Chickasaw Planned Unit Development Joint FMPC/BOMA Conceptual Project Workshop June 22, 2017

Project Description: Chickasaw Planned Unit Development

Circulation System

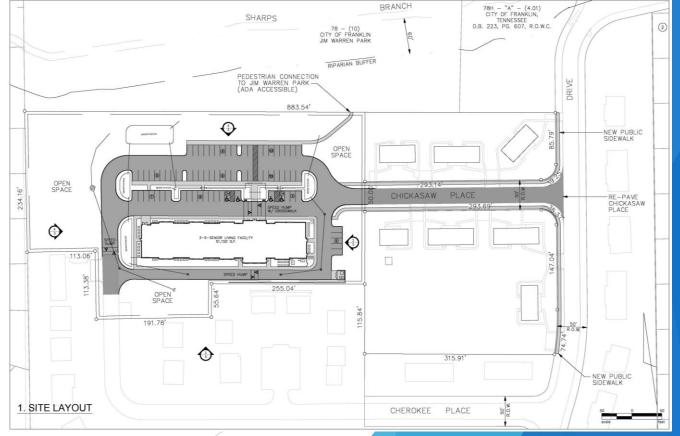
- Discussion concerning demolition of existing FHA units and replacement with single family housing will be removed from this PUD request.
- 3) Ingress/Egress must allow for 2 access points. This will be accomplished by extension of Chickasaw and Cherokee.

- 4) Speed humps allowable and raised crosswalk to be used on private drive portion.
- 5) Trip generation tables required on layout.
- 6) Public water extension will require a 2-way feed and cannot connect to FHA waterline on Cherokee.

- 14) Show pedestrian circulation for sidewalk connections to existing as well as walking trails to park.
- 15) Discussed existing tree canopy, tree removal mitigation methods, and Franklin Parks Department contract.
